# Technical Bulletin

**Model**  
911 C2/C4/T

**Subject:** Fan Bearing Drive/Belt Damage

**Number**  
9301

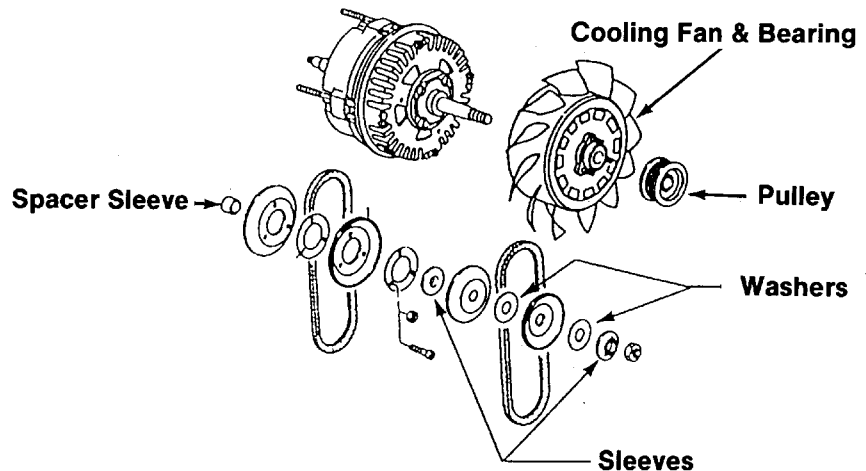
**Concern:** Noisy engine cooling fan bearing /damaged drive belts.

**General Information:** A damaged engine cooling fan bearing can cause the attached parts to run at higher than normal temperatures. Whenever the cooling fan bearing is found to be faulty, the following parts should also be replaced along with any visibly damaged parts.

Description	Part Number	Intro into Production
Spacer sleeve	964 106 515 01 (formerly 00)	8/24/92
Sleeve	964 106 211 01 (formerly 00) Manual	8/11/92
Sleeve	964 106 211 31 (formerly 30) Tiptronic	8/24/92
Washers	964 106 268 31 (formerly 30) Tiptronic	N/A

Description	Part Number	Intro into Production
Pulley	930 106 124 02 (formerly 01)	8/26/92
Spacer sleeve	964 106 515 01 (formerly 00)	8/24/92
